Memorandum

8 November 2021

City of Lee's Summit – Planning and Development Services Department
Plan Reviewer – Joe Frogge

Project: Plan Review Comments #1 / Revision #2.
FIT Muscle and Joint Clinic
413 NW Murray Road
Lee's Summit, MO 64081

A101

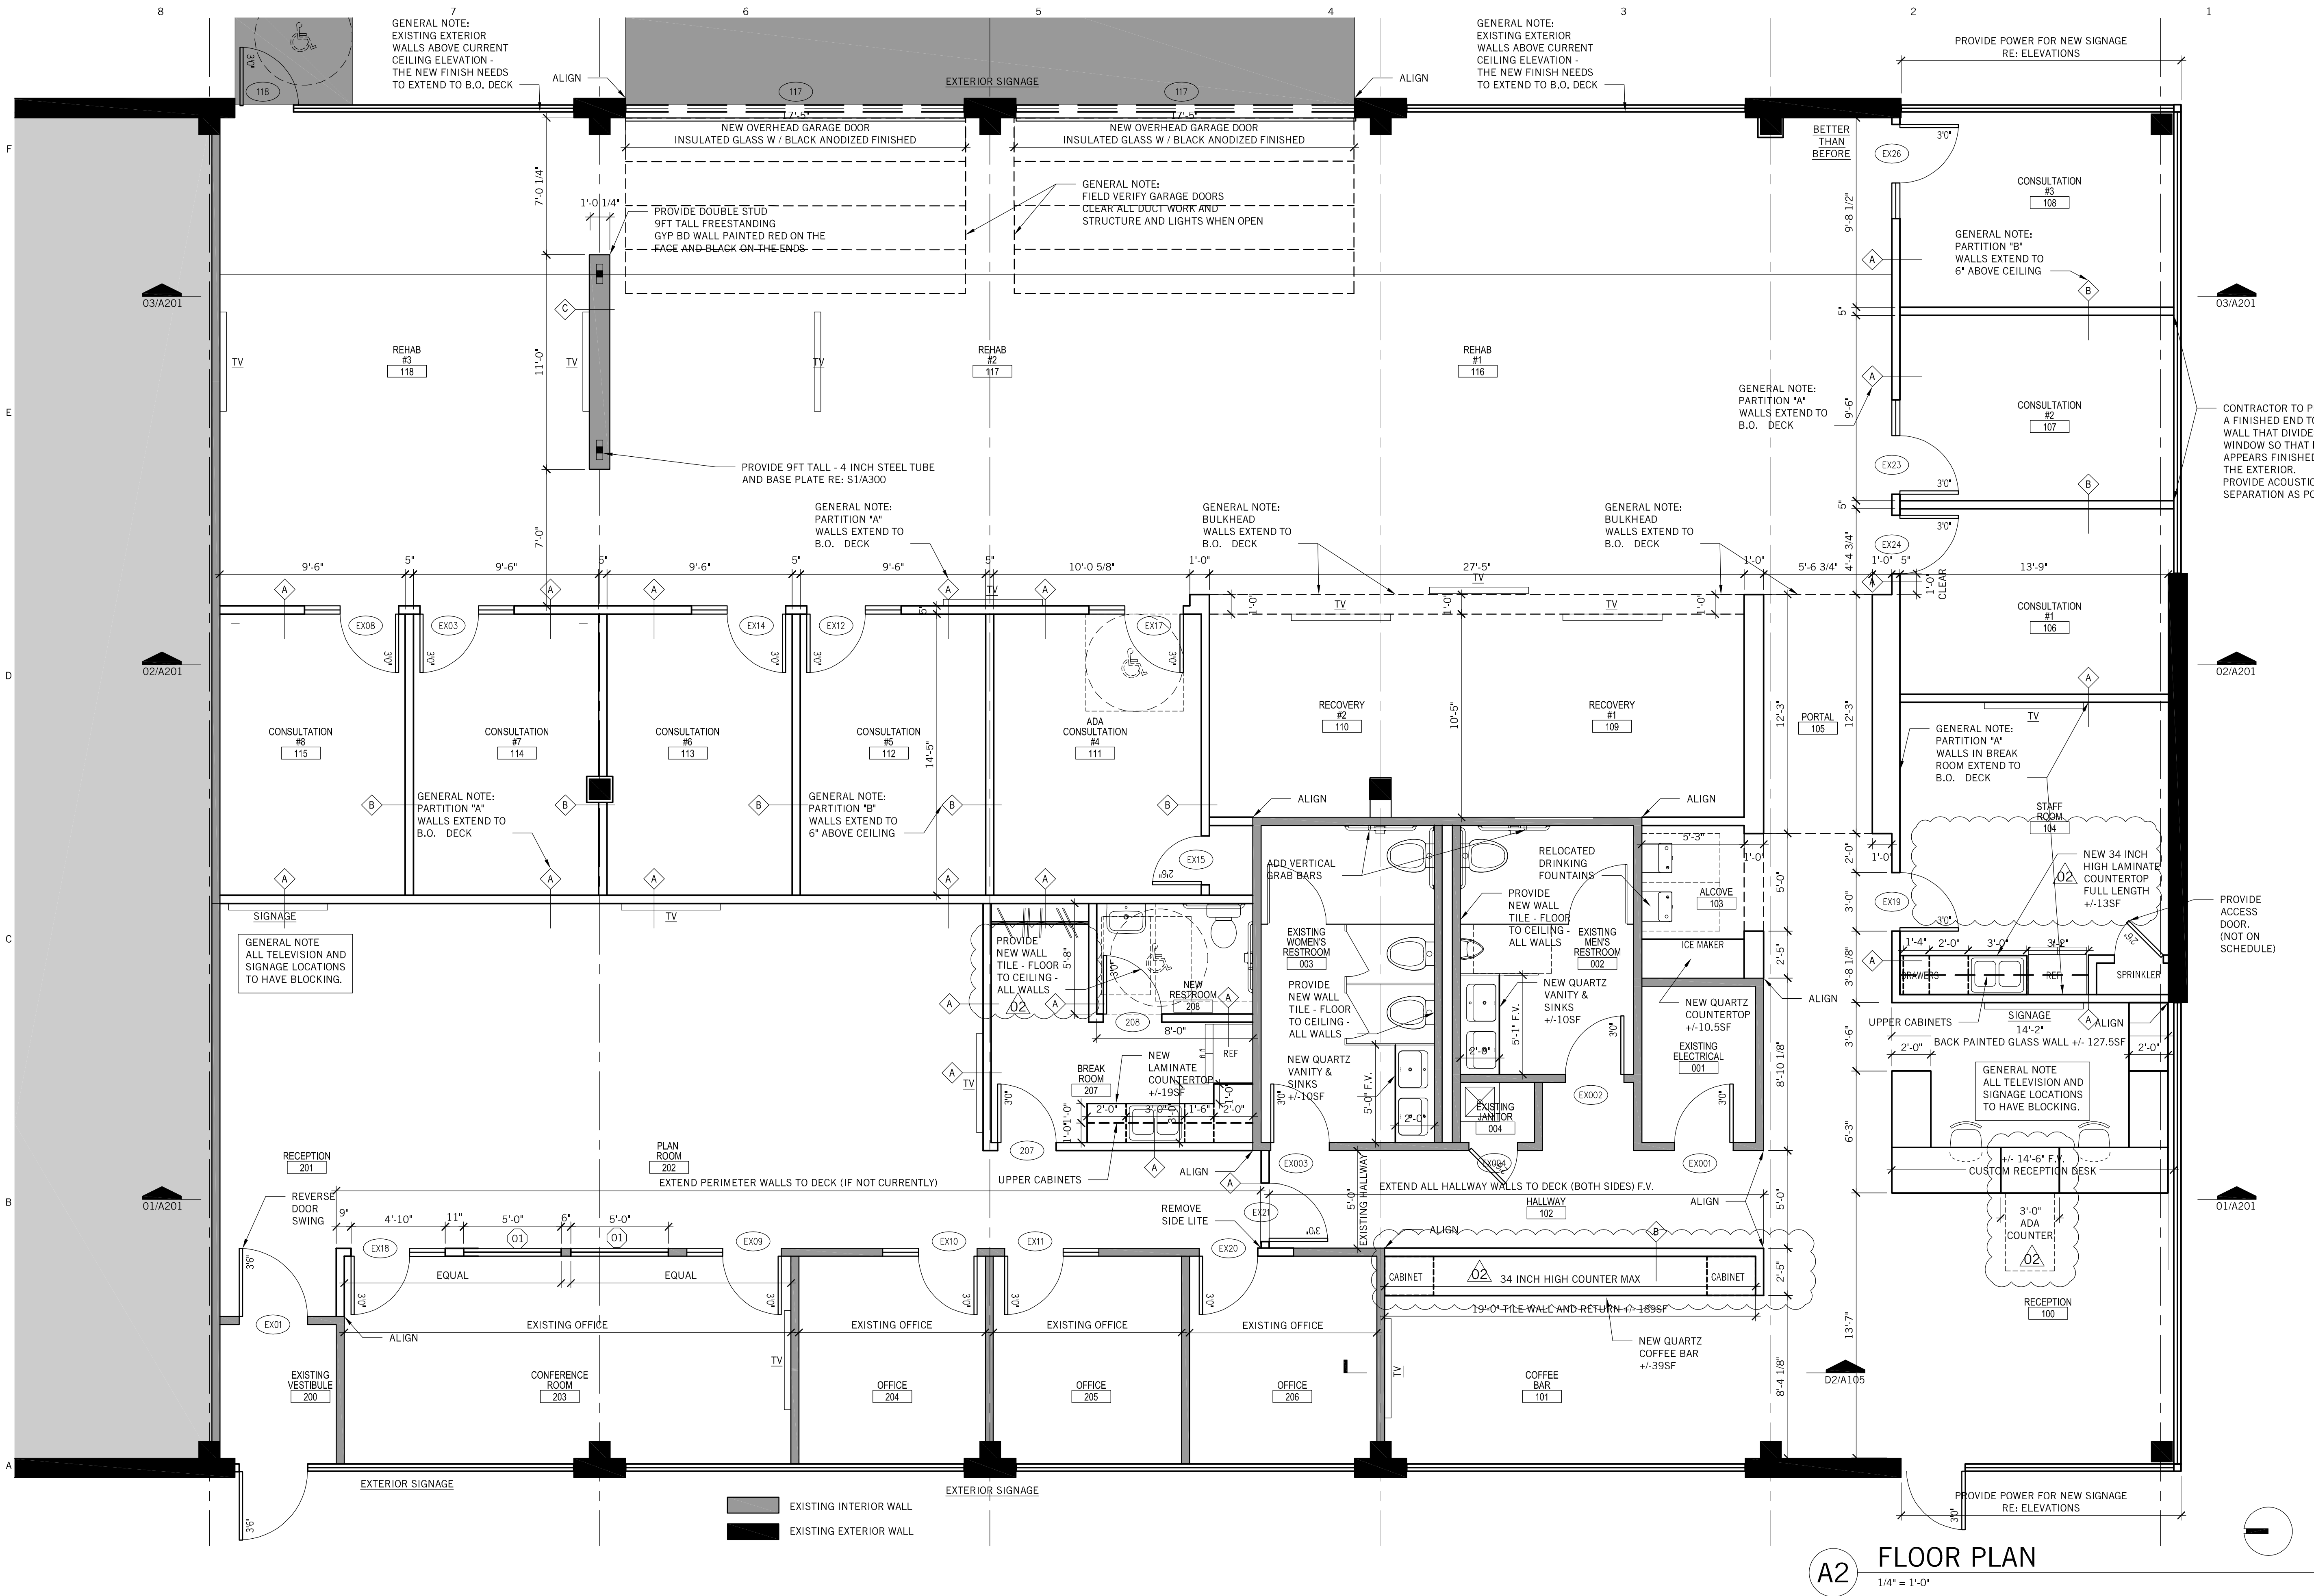
1. 2018 IBC 1109.11 Seating at tables, counters and work surfaces. Where seating or standing space at tables, counters or work surfaces is provided in accessible spaces, at least 5 percent of the seating and not less than one, shall be accessible. (see code for exception)

Action required: Modify plans to show that coffee bar and break room counters will be maximum 34" high.

2. 2018 IBC 1209.2 Finish Materials. Walls, Floors and partitions in toilet and bathrooms shall comply with Sections 209.2.1 through 1209.2.4.

Action required: Specify compliant wall finish material at restroom 208. If Paint is used it must be epoxy based.

1) Response: ADA Counter Height for the coffee bar and ADA Approach notes have been added to A2/A101

- 2) Response: Full Height Tile for all walls in Restroom 208 has been indicated on A101

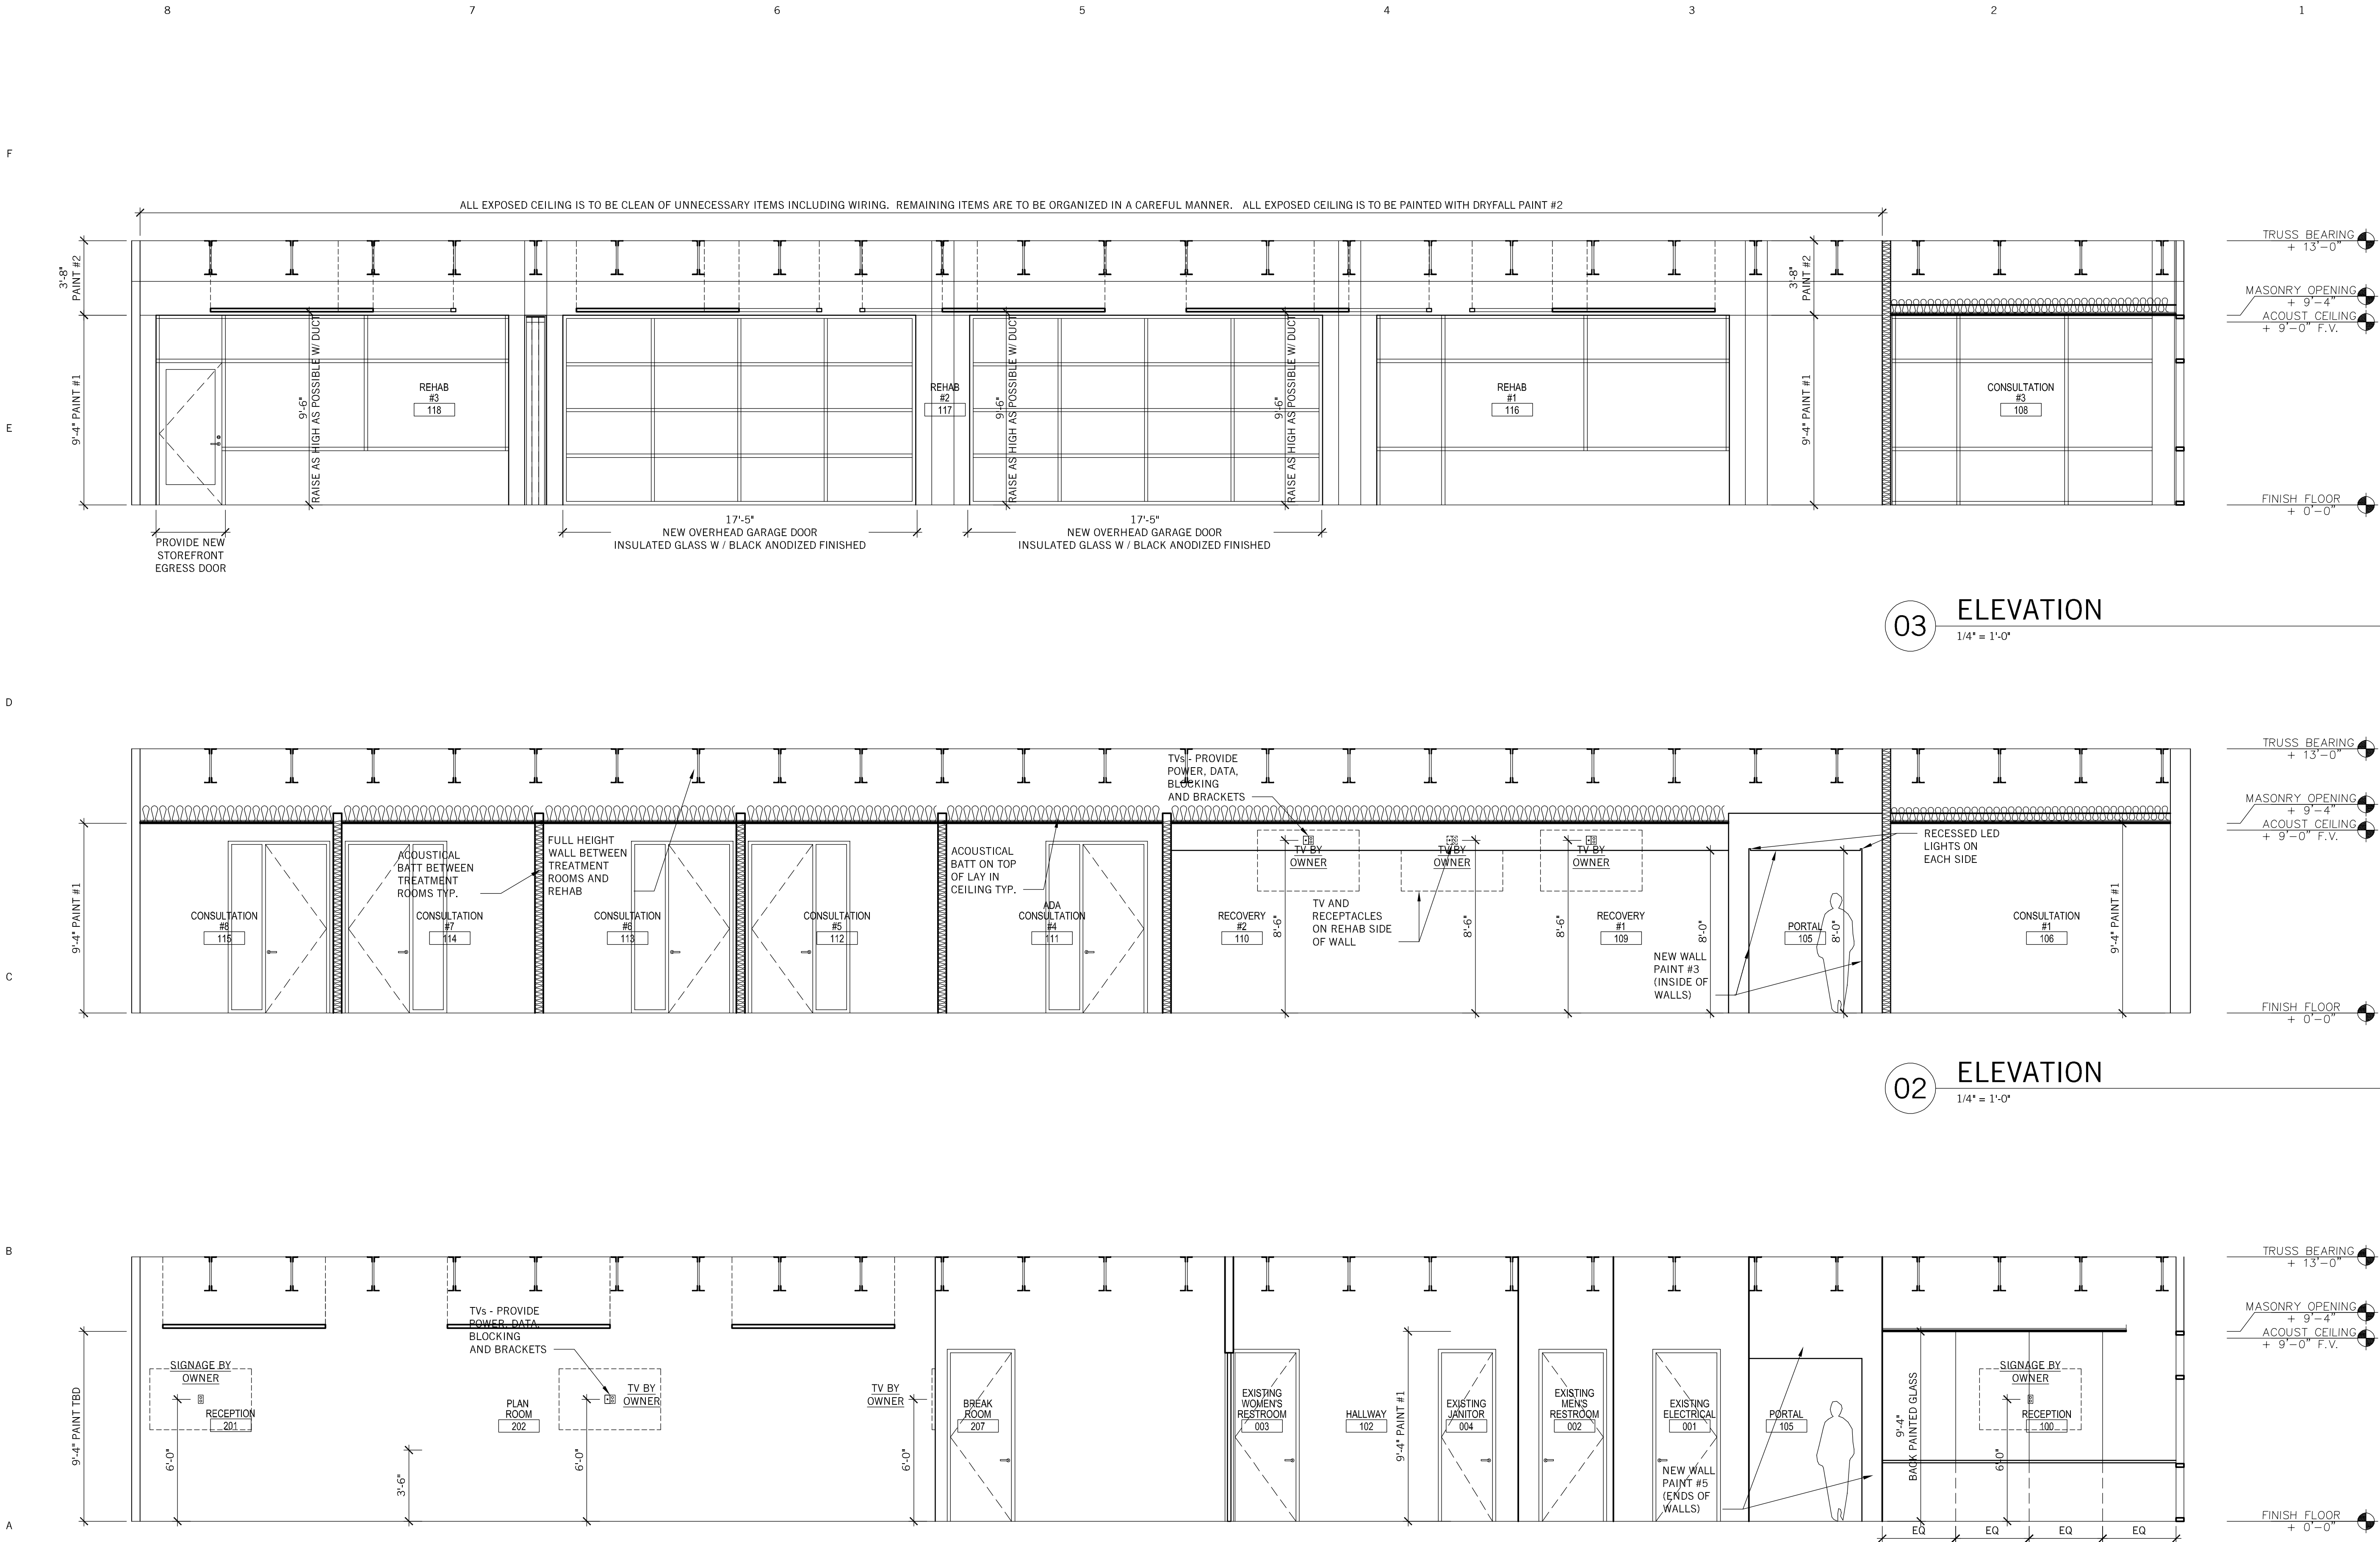
4. 2018 IFC 1008.1 Illumination required. The means of egress, shall be illuminated at all times the building space served by the means of egress is occupied.

Provide exterior emergency lighting at the exit doors.

4) Response: Emergency Exit lighting has been updated on A102, A200 and E101.
